CITY OF KIRKLAND
Planning and Building Department
123 Fifth Avenue, Kirkland, WA 98033
425.587.3600 ~ www.kirklandwa.gov

To: Design Review Board
From: Aoife Blake, Associate Planner
Date: August 6, 2020
File No.: DRV 20-00417
Subject: **WEBB BUILDING
DESIGN RESPONSE CONFERENCE**

**WEBB BUILDING DRC
DRV20-00417**

Webb Building

BUILDING
 ELEVATIONS

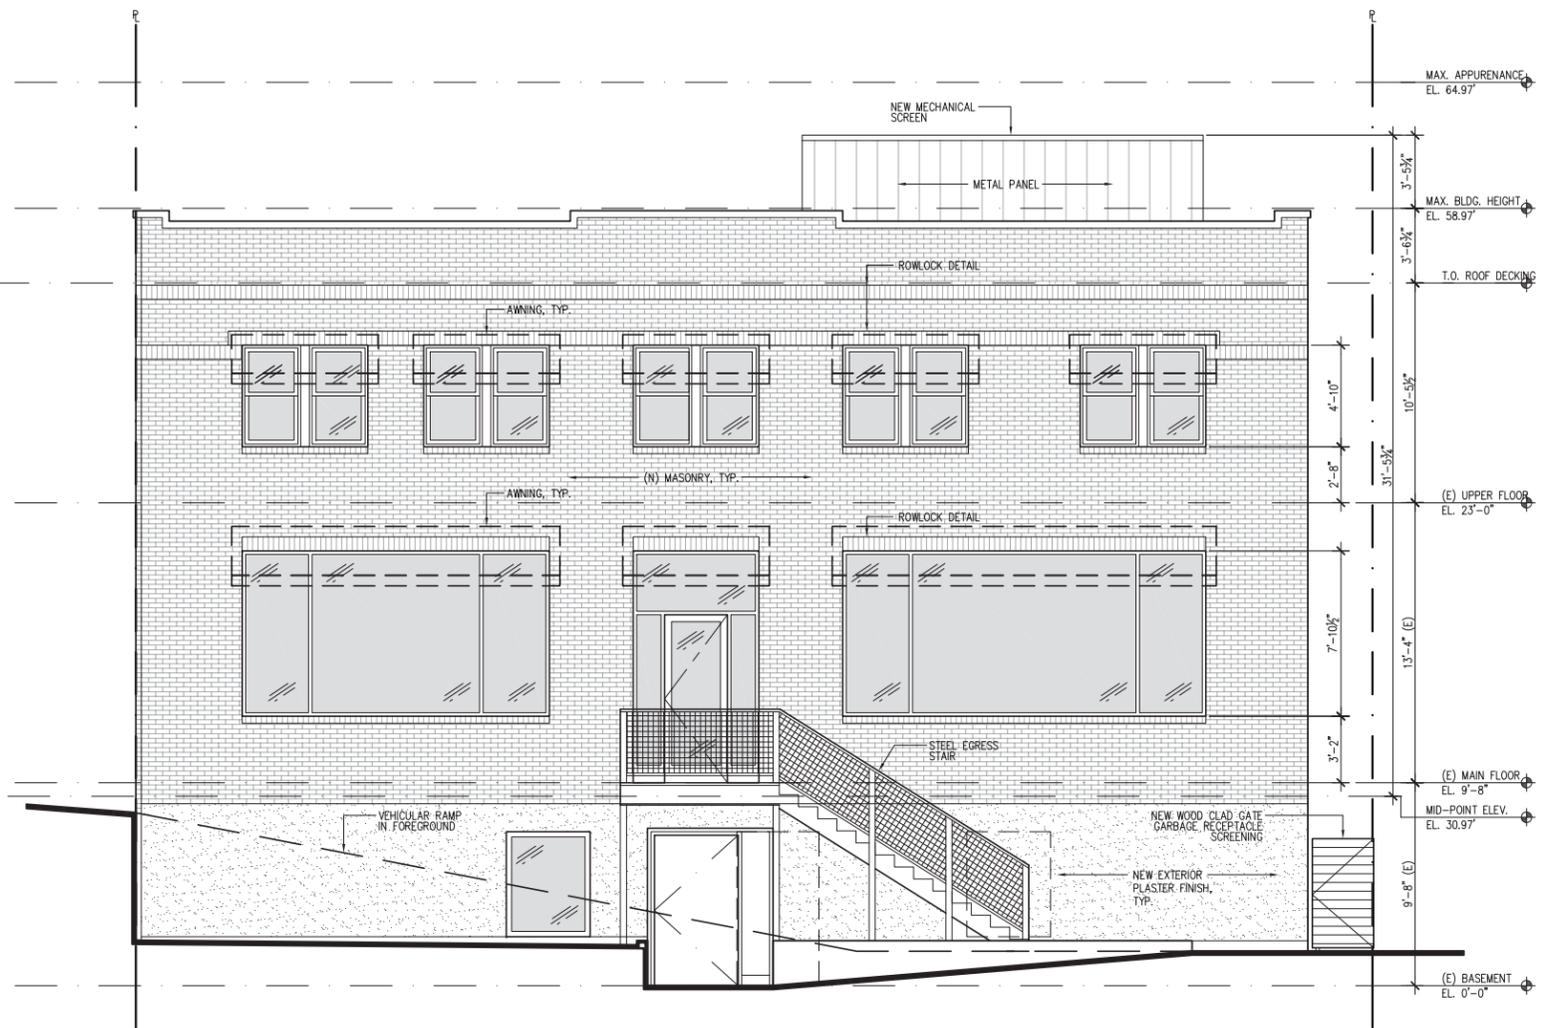
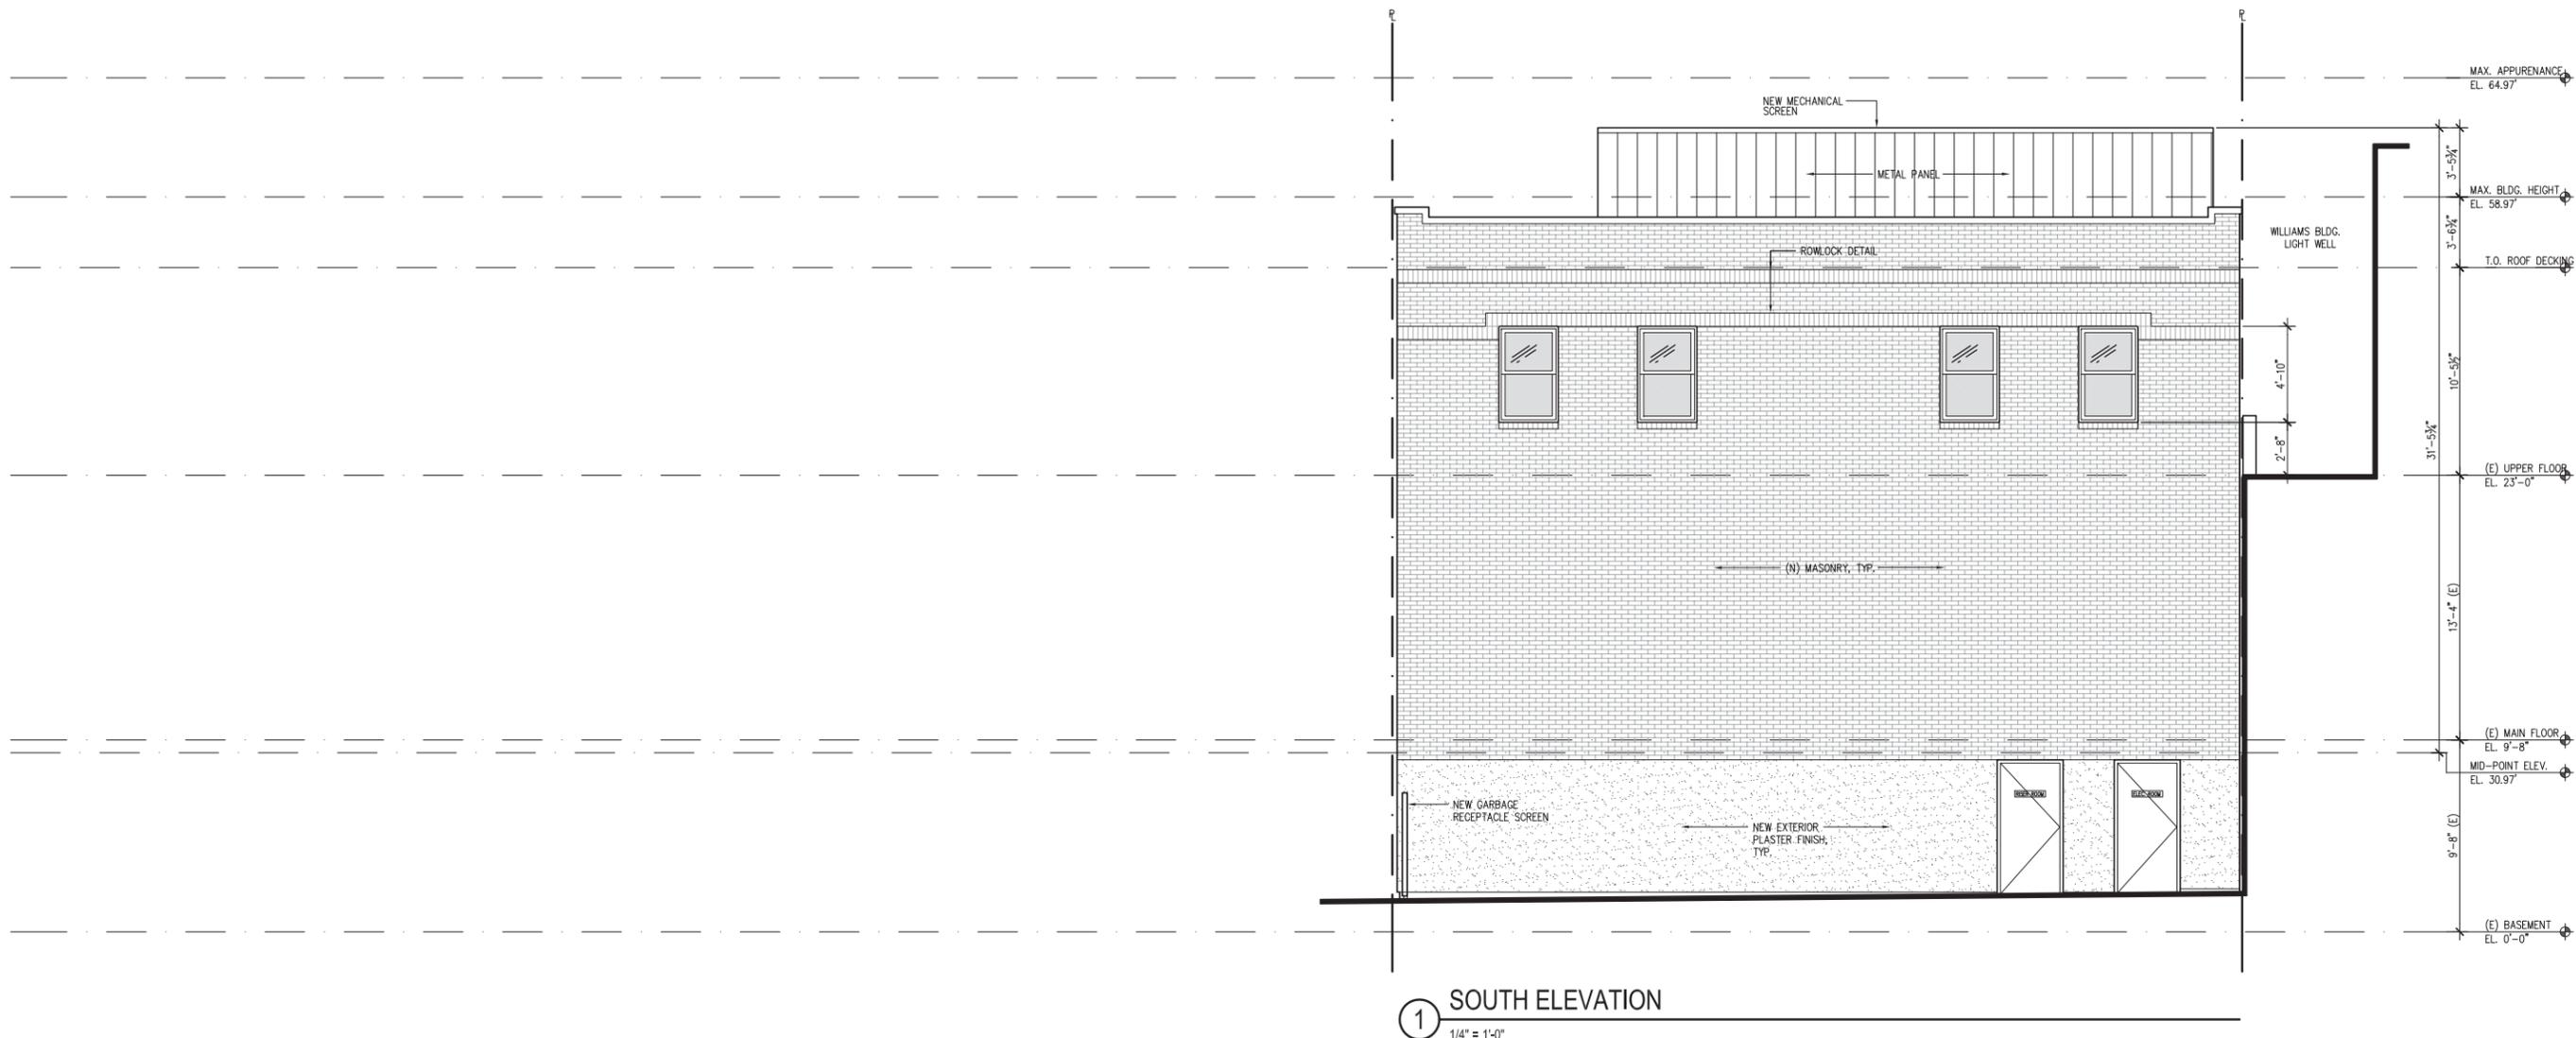
- On pages 7 & 13, the applicant addresses the DRB comments regarding the type, size, and number of fenestrations along the west façade.

The applicant proposes to mirror the fenestration pattern on the north façade along the west façade. The double-hung windows proposed for the upper floor compliment the character of the

existing windows on the north façade. The spacing of these windows is not uniform but do align with the corresponding lower windows and door.

Staff recommends that the DRB discuss the design guideline recommendations that promote fenestration patterns when considering the proposal and staff's comments. See further staff analysis in the Building Materials, Color's and Details below.

- On page 13, the applicant illustrates continuity of the historical building details such as the parapet and rowlock brick (lighter colored horizontal brick pattern) along the west and south facades. The parapet along the west façade is proposed to mimic the rhythm of the north façade with "step-ups" at the north-west corner, the middle, and the south-west corner of the west façade. The rowlock brick detail from the front façade is continued around the building on the west and south facades.

- What recommendations does the DRB have about the fenestration pattern along the west facade?
- What recommendations does the DRB have regarding the historical building elements such as the parapet and rowlock brick detail?

In response to the DRB comments, the applicant has refined the façade renovations to maintain the historical character of the building. Attachment 2, page 7 contains elevation drawings that illustrates maintaining historical building details on the north façade, such as cornices, rounded edges of the windows on the north facade building plaque and parapet. Pages 7-8 and 14-15 show building details from the north facade being reflected on the west and south façade with fenestration pattern, rowlock brick detail, and the parapet design.

① SOUTH ELEVATION
 1/4" = 1'-0"

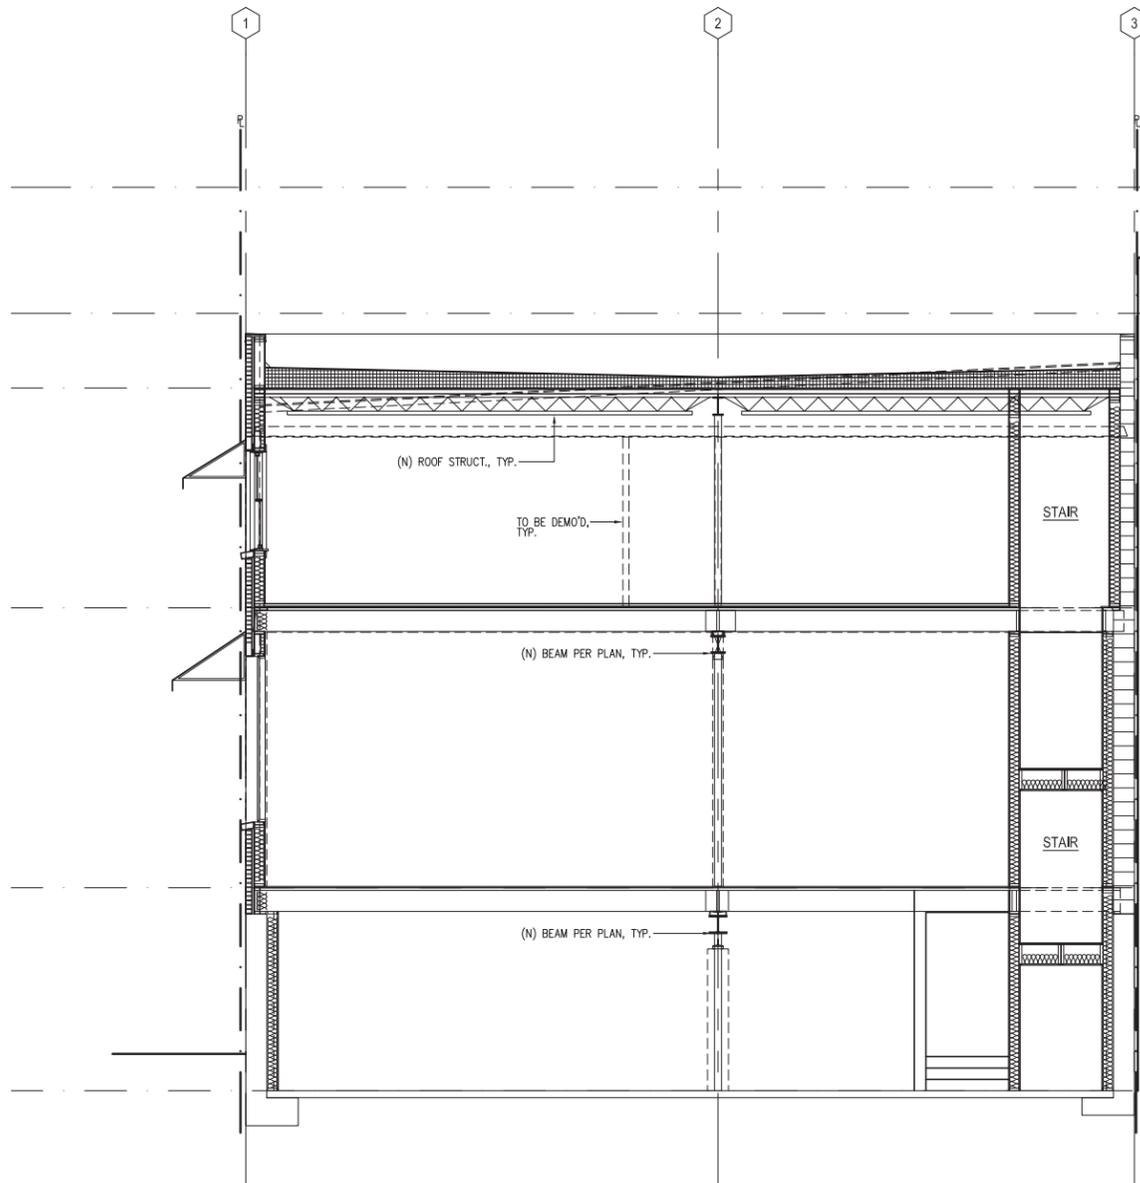
- Building details proposed along the west and south façade,
- Building materials and colors

Proposed brick tones, T.B.D.

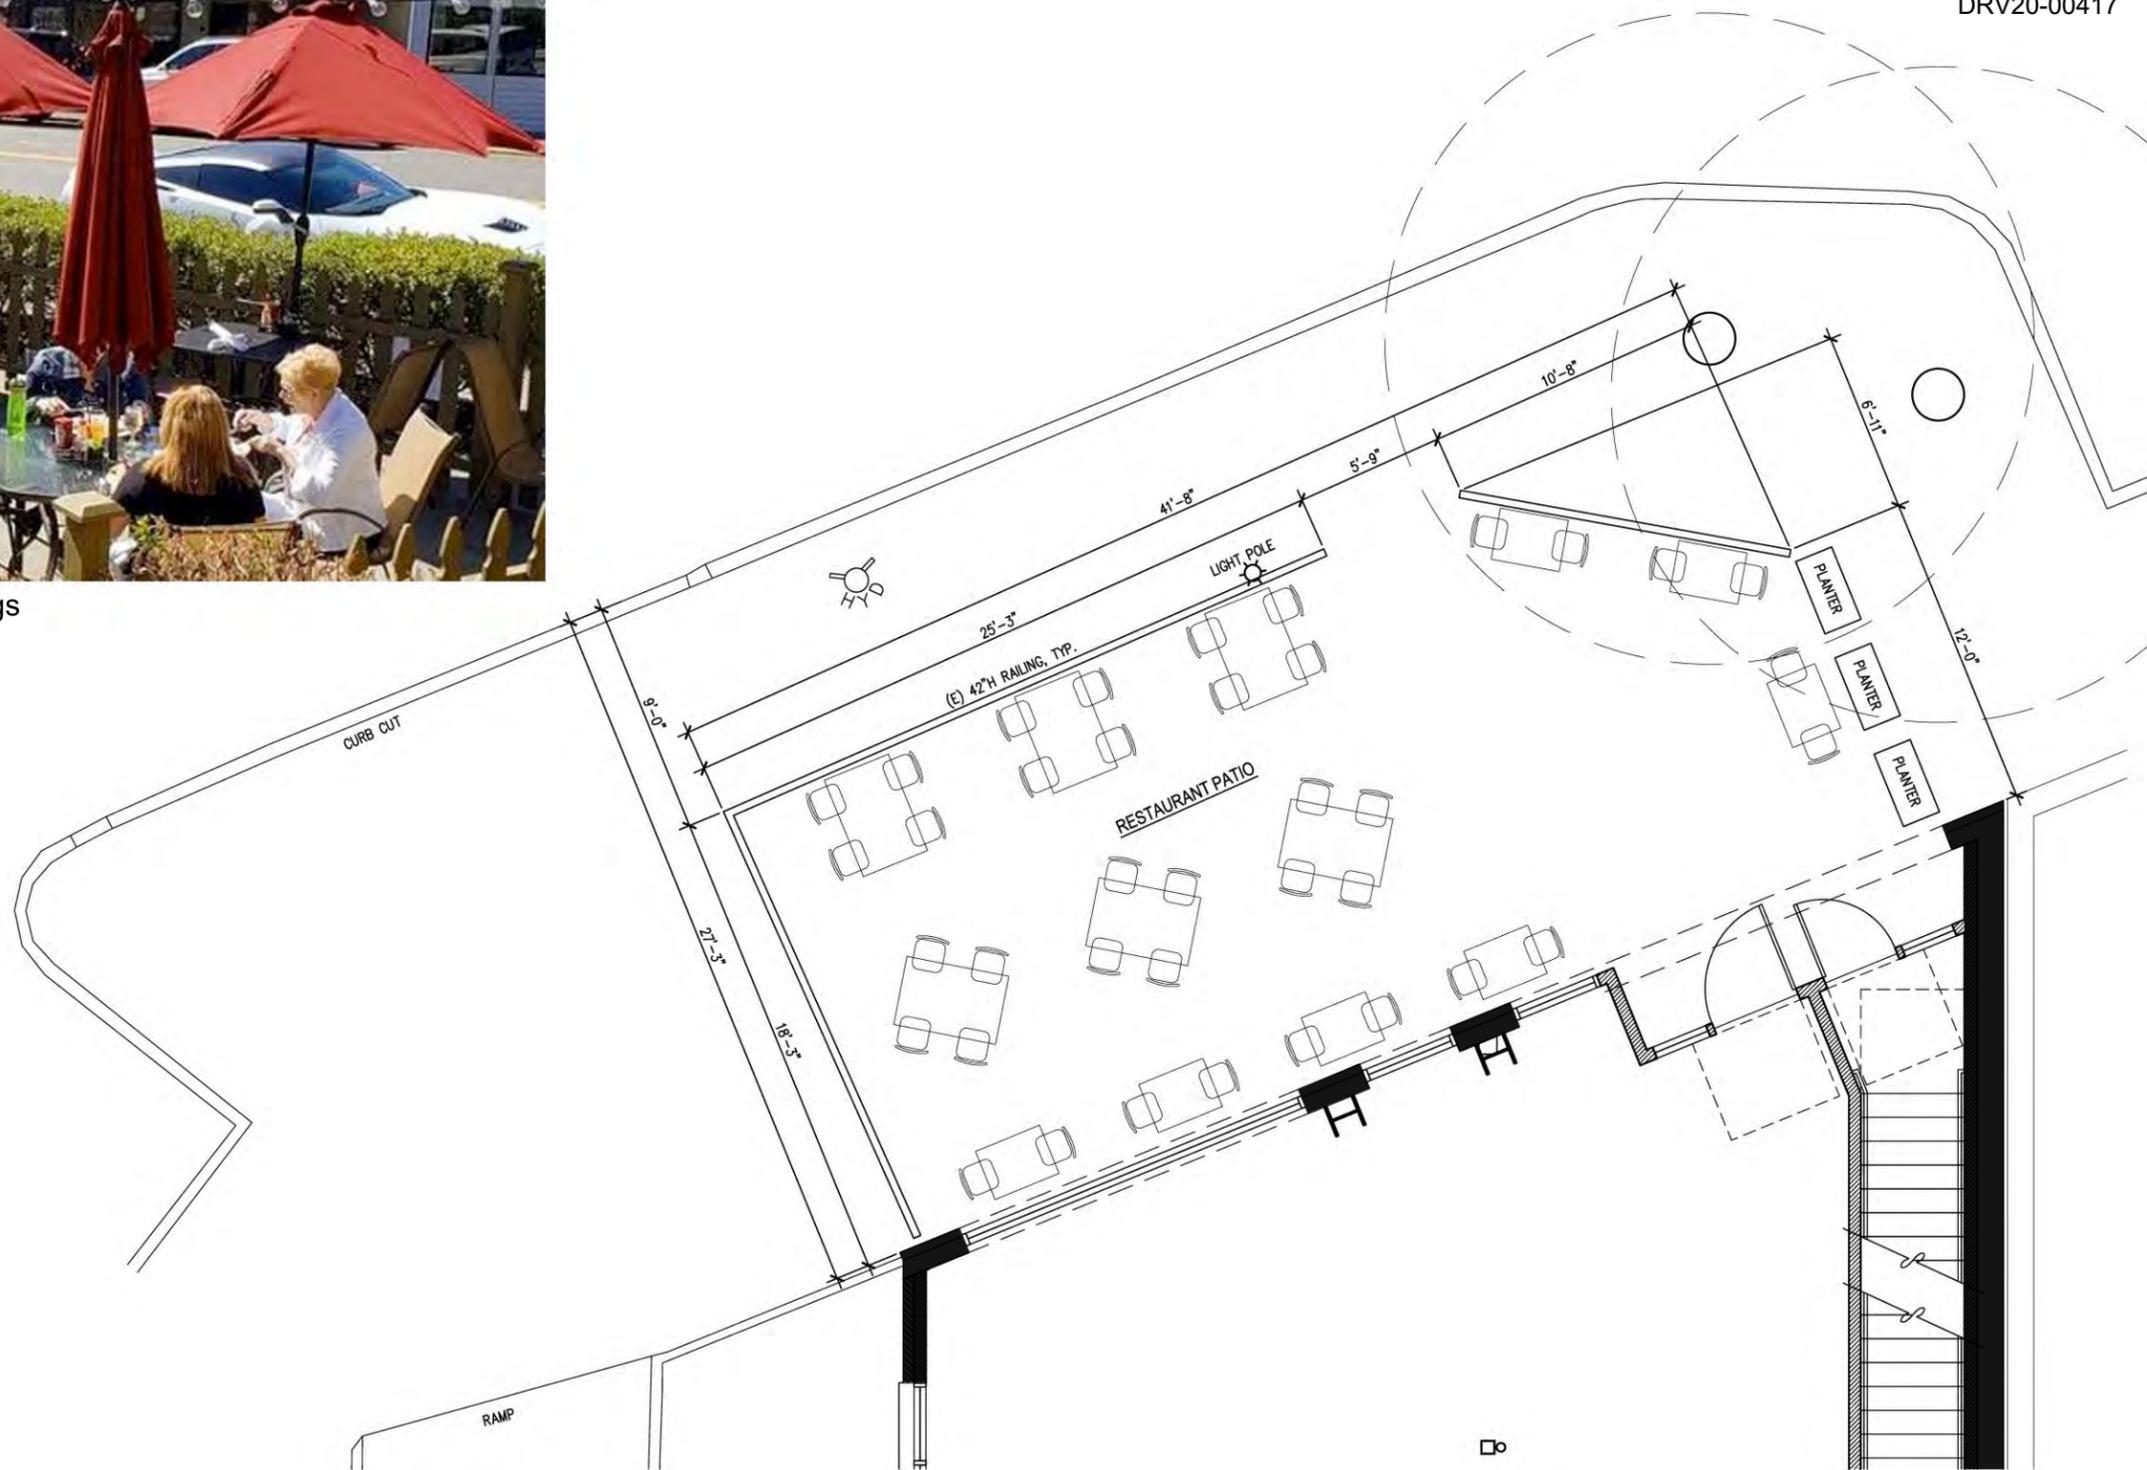
On page 15, the applicant has provided two color palette options for the brick veneer on the west and south building facades. The applicant's intent is to use a brick that compliments the existing brick on the front façade and is proposing a color similar to the darkest brick color on the front façade with a lighter shade for the rowlock detail.
